M MORRIS
RAZR

RAZR DRILL TRAINING
Module 5 : Bulletins & Updates for 2016

ASSEMBLY 254 – SECONDARY HOSE INSTALLATION

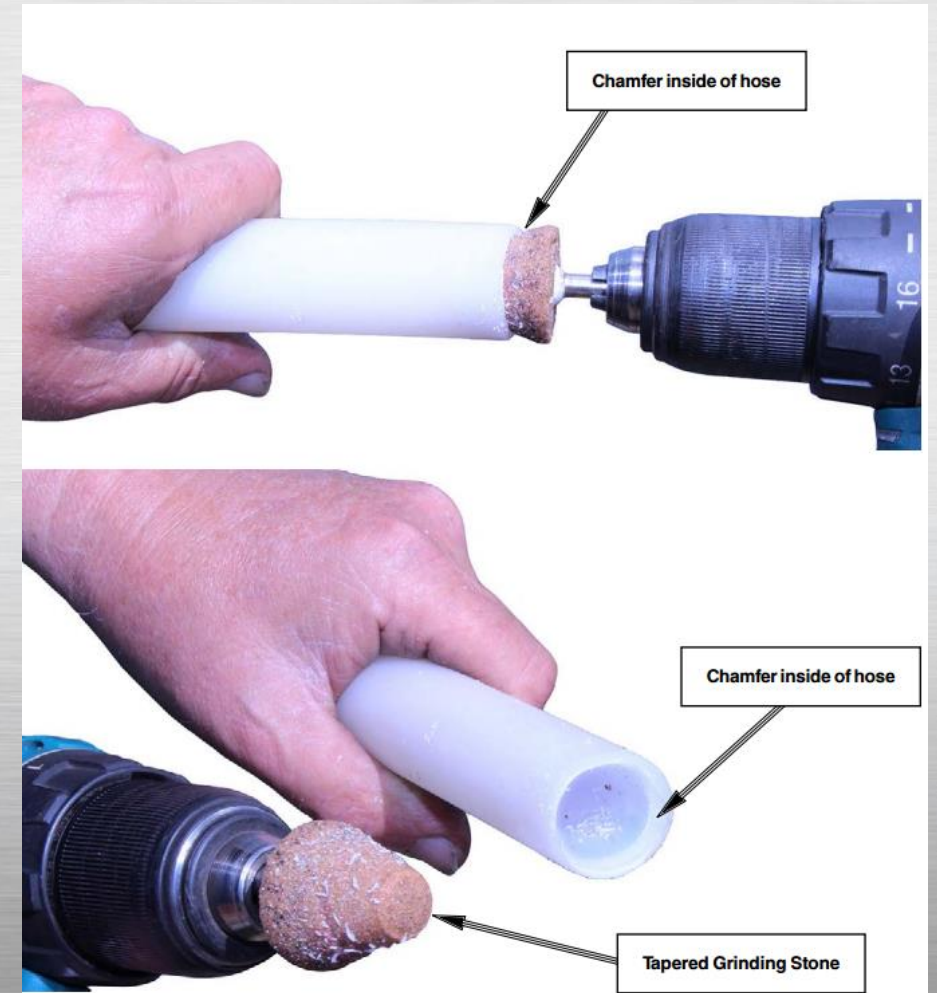
Morris has removed the dimpled end on the Divider Head outlets for the secondary hose to improve system air flow.

For ease of installation of the secondary hose, use a tapered grinding stone to chamfer the end of the hose as illustrated prior to heating the hose end in hot water.
